PB25-0792, 1 Ocean Drive
2/3/2026 meeting "Exhibit A"

Objections and Protests to Application PB25-0792

Stearns Weaver Miller for Penrod Bros. Inc.

Date: January 5, 2026
Prepared by: Arturo G. Griego, G3 AEC
Subject: Analysis of Modifications and Non-Conformance in Recently Submitted Project Plans Compared to the Authorized Proposal
To: Maria A. Fehretdinov, Esq. Stearns Weaver Miller, for Penrod Bros. Inc.

Non-Conformity with Required Project: Complete Demo & Larger New Construction

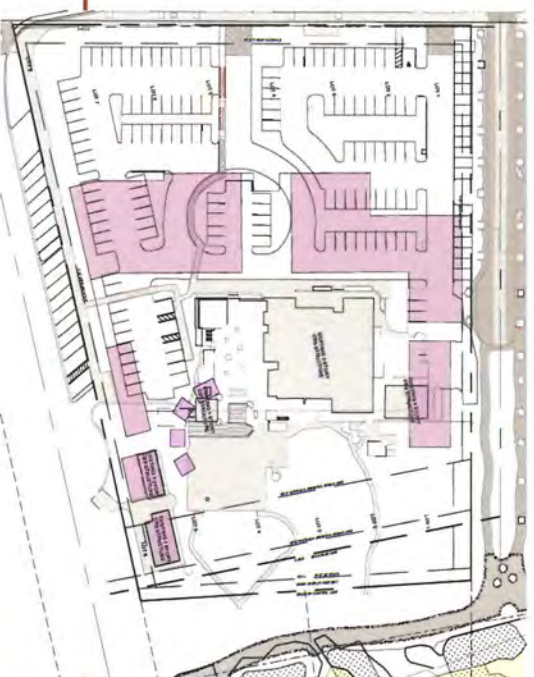
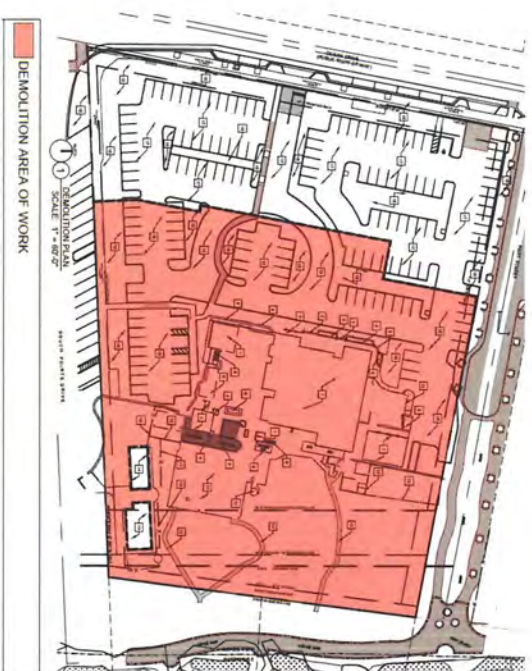
- Maintain existing structure
- Maintain parking format & location
- Maintain main building footprint
- Total operational SF of 73,600
- Lot coverage of 13%
- Reduce construction waste

- Total demolition, new construction
- Construction of parking understorey
- Increase in footprint by 7,745 SF
- Increase operational SF by 10,700 SF
- Lot coverage of 41%
- Increase to 141,000 SF of demolition

Required: Maintain Existing Structure

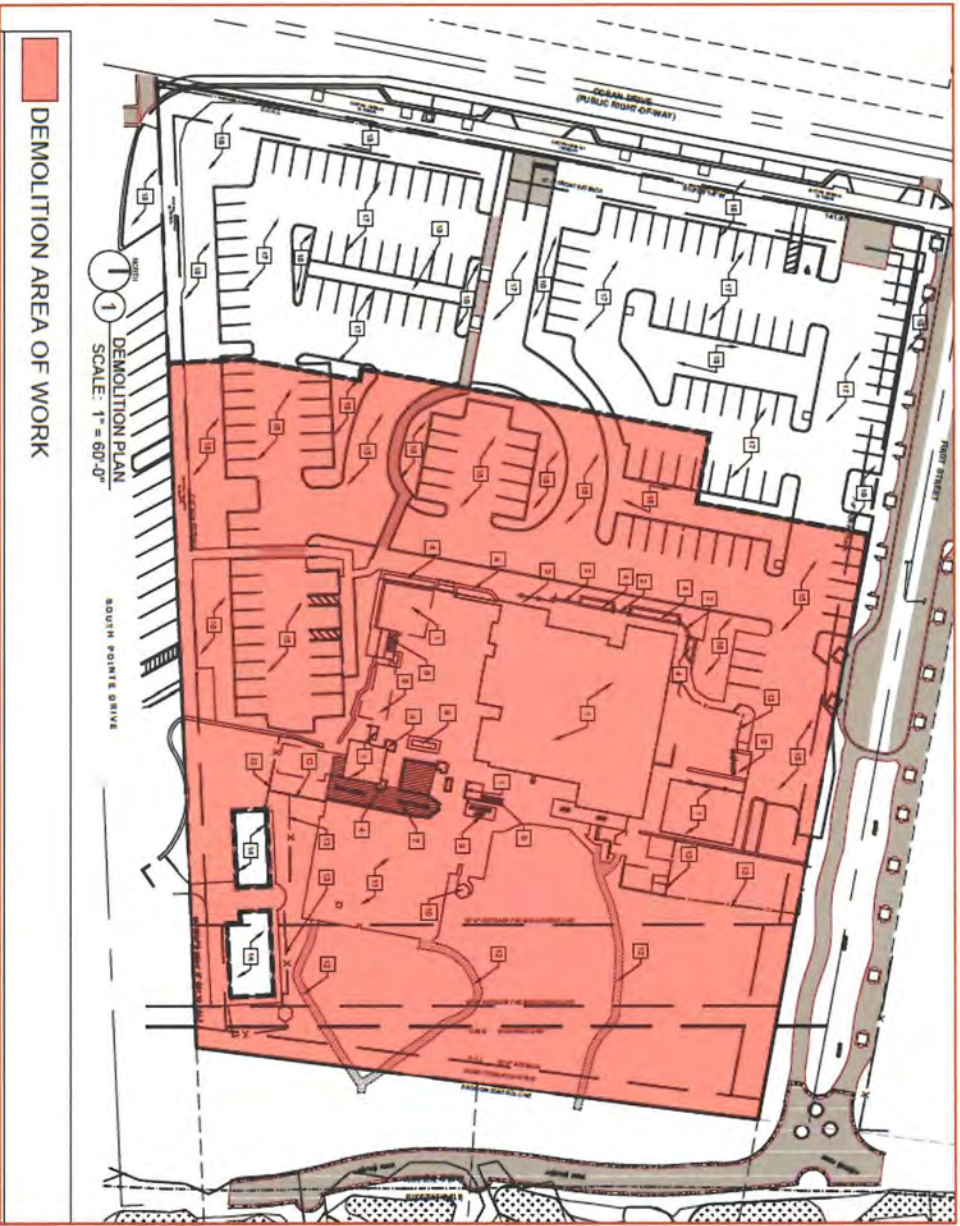
goal of having a minimum 85% waste diversion rate. Along with maintaining existing structures, we will aim to reuse and reintegrate a significant portion of the existing site materials in the project

CITY EVALUATOR: So you're not proposing [] any tear-down and rebuild from scratch?
APPLICANT: Correct.
ARCHITECT: Correct. That is correct. . . what we're looking to do is we're looking to take the existing building, and, basically, we're going to rehab it.

Under story: 55,168.57 SF
Additional structures: 4,973.15 SF
2. PROPOSED UNDERSTORY LEVEL

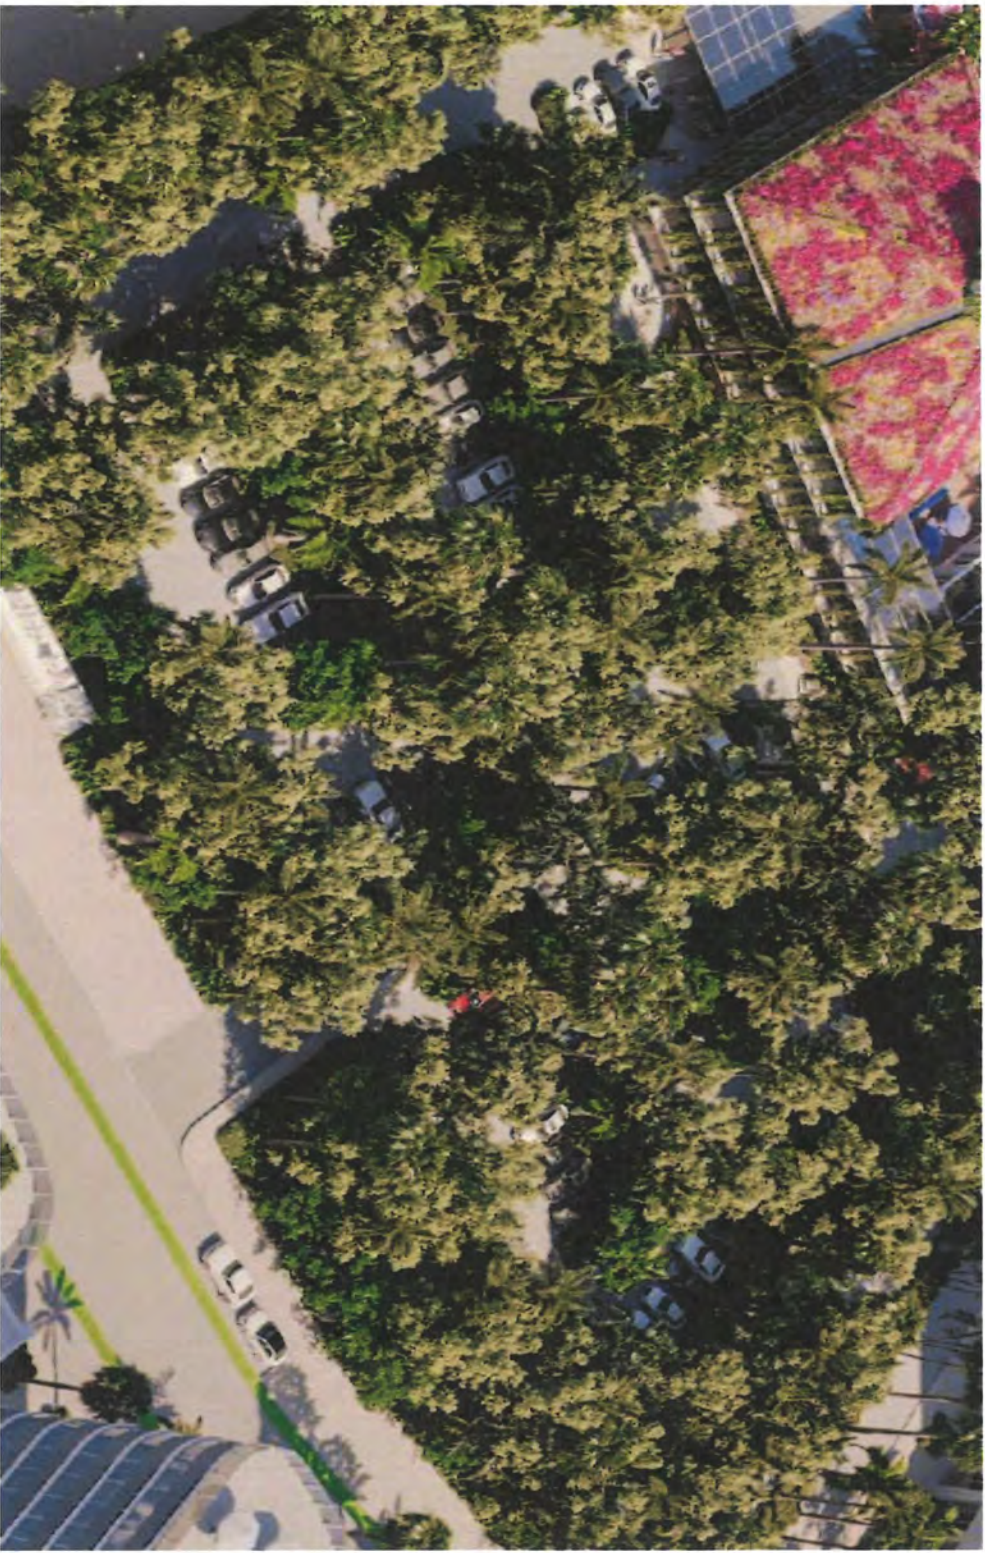
Required: Maintain Parking Format Request: New Parking Under-Story

Non-Conforming Request: New Parking Under- Story

6. PROPOSED BUILDING FOOTPRINT
Building Footprint: 28,277.88 SF

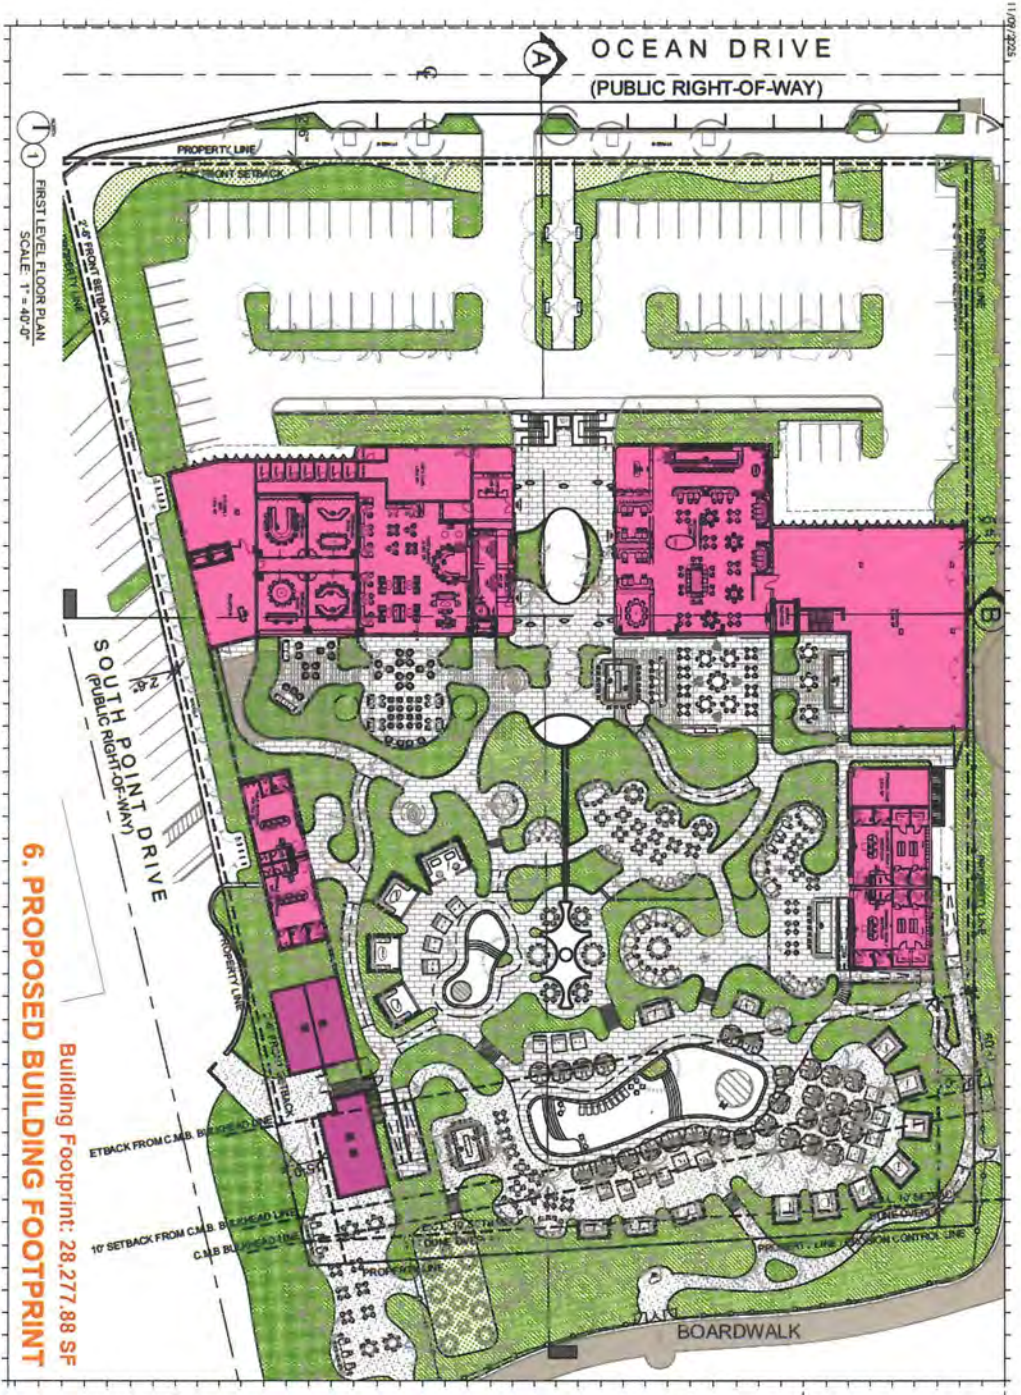
Required: Maintain Footprint Request: Relocation & Increase Footprint

Non-Conforming Request: Relocation & Increase Footprint

Non-Conformity with Required Project: Elimination of Sustainability Features

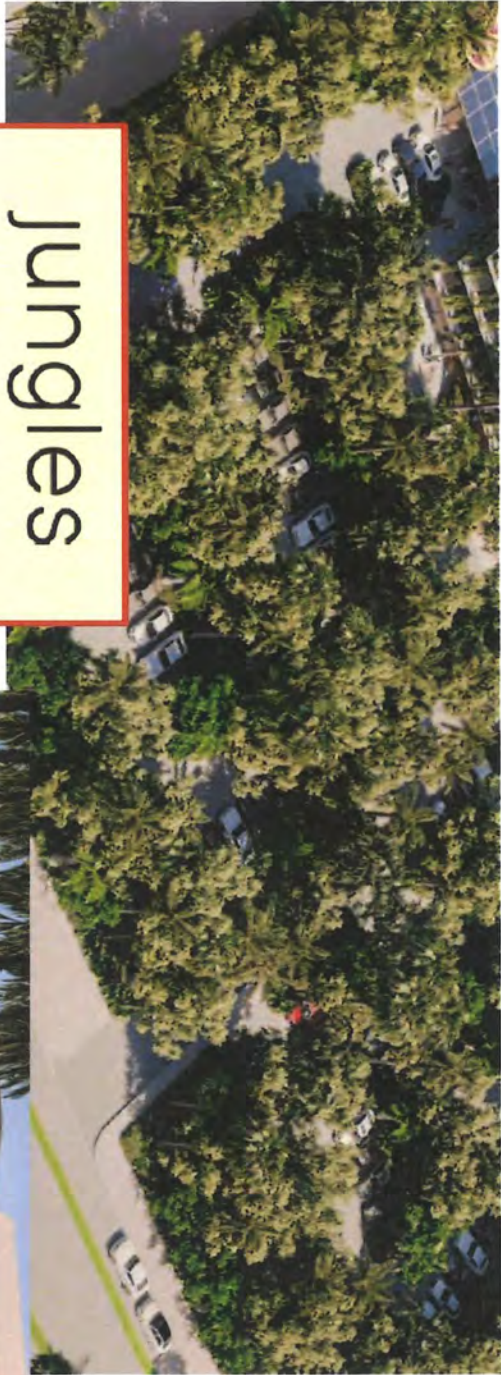
- Increased “jungle” tree canopy
- Sustainable surfacing
- Resiliency feature of solar panels
- Location of pools & amenities alongside restaurants

- Reduced tree canopy
- Increase impervious surface by 18%
- Elimination of solar panels
- Relocation of pools and addition of multiple water features, increasing maintenance and safety risks

Non-Conformity with Required Project: Increased Intensity

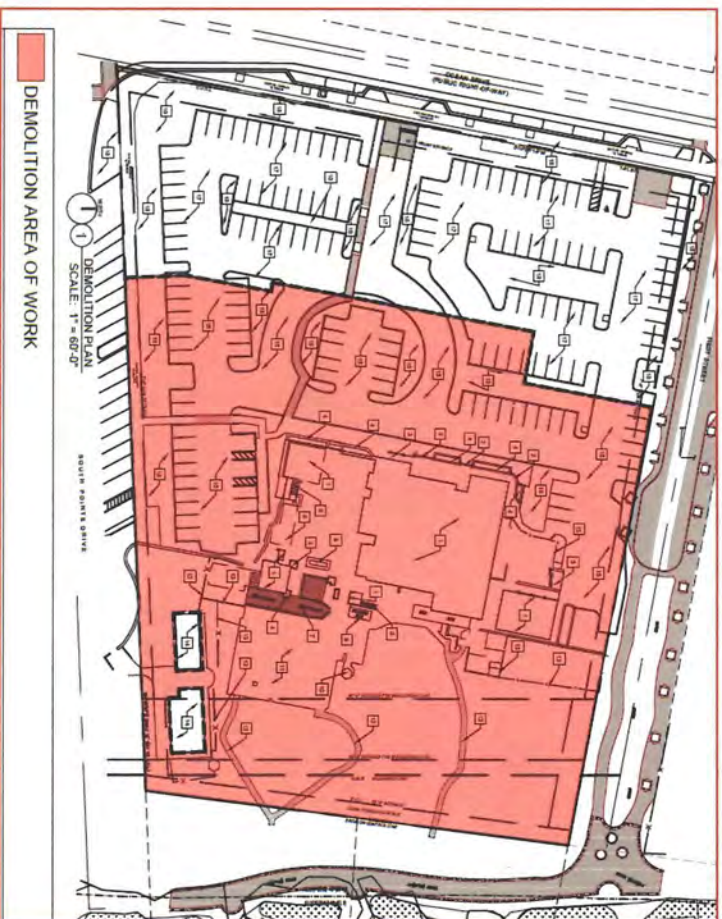
- No reduction in parking during construction
- Traffic flow consistent with existing structure
- 13 month construction timeline
- FAR (GFA) of 23,343 SF

- Demolition and closure of parking site for construction
- 4x increase in traffic
- Revised scope estimated to increase construction to 24-30 months
- FAR (GFA) increase of 650 SF

19. Construction Timeline:

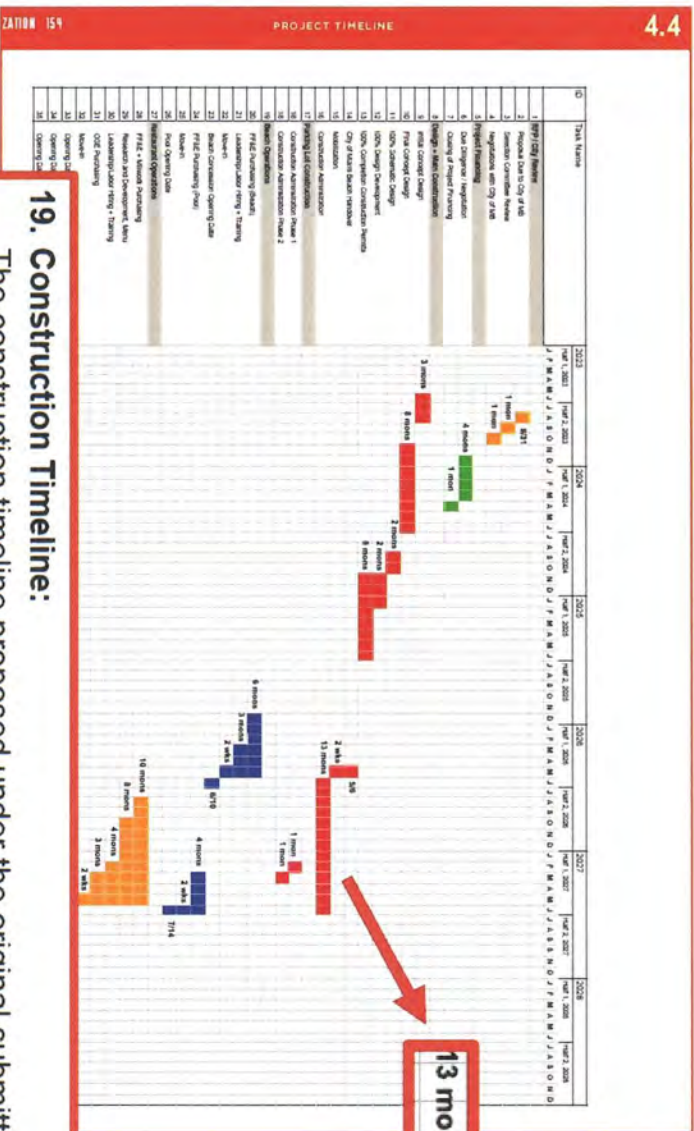
Required: 13 Month Construction Timeline

Request: 24-30 Month Construction Estimate

The construction timeline proposed under the original submittal was 13 months, excluding design and permitting. Given the expanded scope of work in the revised proposal, the construction duration would be substantially increased.

The proposed demolition and construction of the understory will require additional time, as will soil preparation for foundations and coordination of civil infrastructure improvements. These elements represent a significant schedule impact when compared to the previous proposal, which was more limited in scope and involved less vertical construction volume.

Based on the revised scope, a conservative estimate for the construction duration would be approximately 24 to 30 months.

1 PROPOSED LOT COVERAGE
SCALE: 1" = 80'-0"

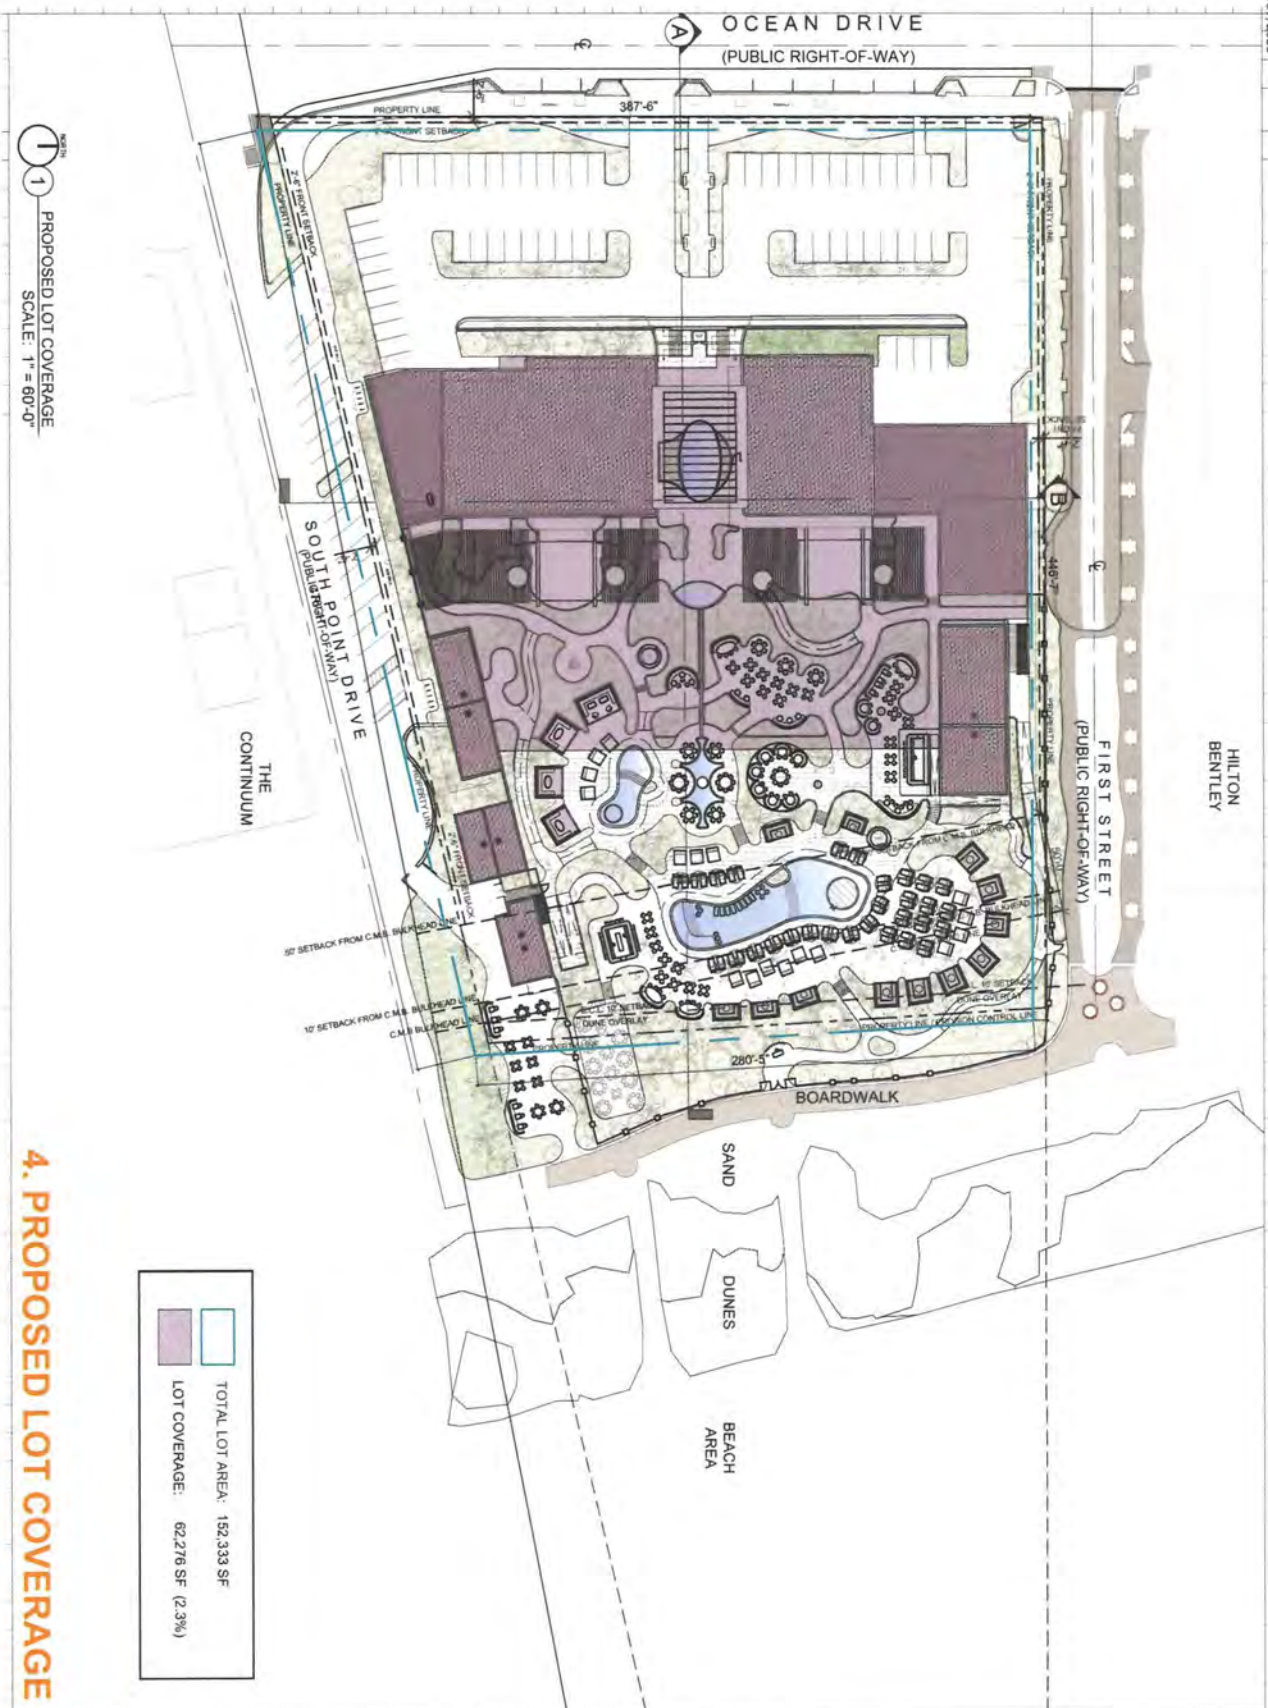
Lot coverage is significantly higher in the new plan, primarily due to the understory and its associated footprint. Impact: Reduces open space, potentially affecting site aesthetics, drainage, and compliance with zoning requirements.

Quantified Difference: Original: **20,531 SF = 13.5%**; Recently Submitted: **62,726 SF = 40.8%**; Net Increase: **42,195 SF = 27.3%**.
